Product Change Notification

Change Notification #: 115584 - 01

Change Title: Intel® DSL6340, Thunderbolt™ 3 Controller,
Product Code: DSL6340,
T&R MM# 944560, Tray MM# 944559,
Intel® DSL6540 Thunderbolt™ 3 Controller,
Product Code: DSL6540,
T&R MM# 944697, Tray MM# 944698,
Intel® JHL6240 Thunderbolt™ 3 Controller,
Product Code: JHL6240,
T&R MM# 948590, Tray MM# 948591,
Intel® JHL6340 Thunderbolt™ 3 Controller,
Product Code: JHL6340,
T&R MM# 950430, Tray MM# 950431,
Intel® JHL6540 Thunderbolt™ 3 Controller,
Product Code: JHL6540,
T&R MM# 950427, Tray MM# 950428,
PCN 115584-01, Product Marking,
Heat Sink Mark Update
**Reason for Revision: Update Ready to Receive
Milestone Date and Impact to Customer**

Date of Publication: January 19, 2018

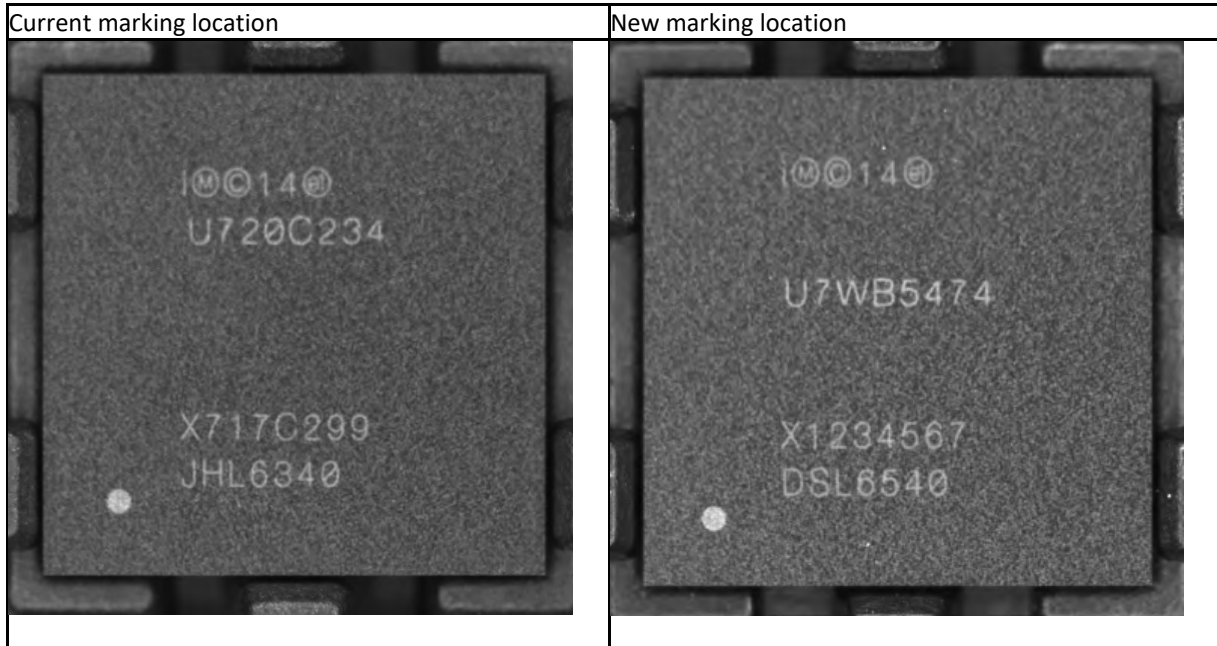
Change gap between EOL mark and MRK mark from 0.4mm to 2.5mm as illustrated in the below pictures.

Intel anticipates no impact to customers as there is no form, fit or function change, only of the marking location change that will be visible.
